Agency Advice on Residual Matters Report

Russell Vale Colliery Underground Expansion Project (MP 09_0013) Residual Matters Report

ATTACHMENT 1: OEH DETAILED COMMENTS ON RESIDUAL MATTERS REPORT, RUSSELL VALE COLLIERY UNDERGROUND EXPANSION PROJECT (MP09-0013)

SYDNEY CATCHMENT AUTHORITY - SUBMISSION
TRANSITIONAL PART 3A PROJECT
RUSSELL VALE COLLIERY UNDERGROUND EXPANSION PROJECT
ASSESSMENT OF THE RESIDUAL MATTERS REPORT
JULY 2014

Figure 1. Major unexplained discrepancies (up to 20,000 ML) in Cataract Dam modelled volumes. Source: WRL (2014).

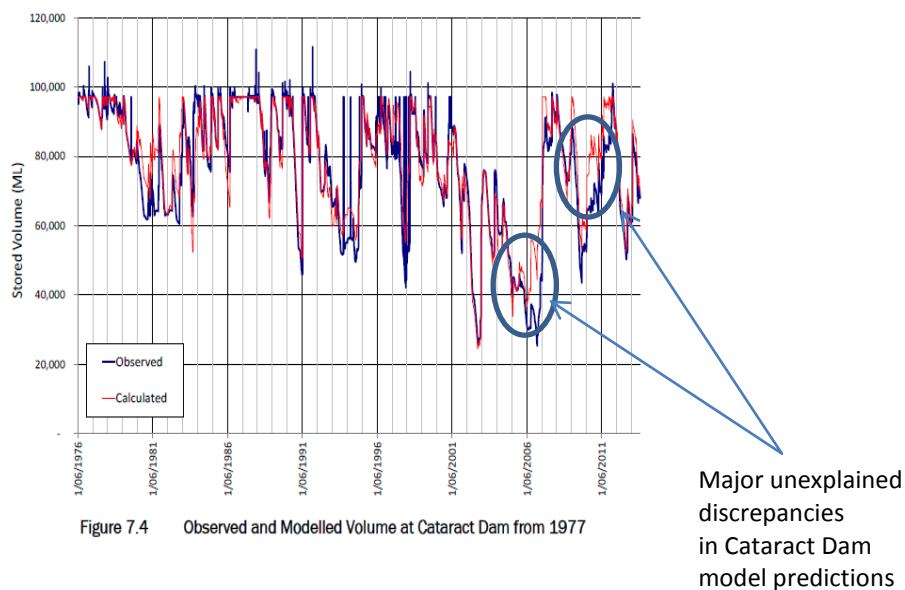
OEH maintains a concern with WRL's (2014) modelling for Cataract Dam, noting major unexplained discrepancies (up to 20,000 ML) in Cataract Dam modelled volumes (Figure 1).
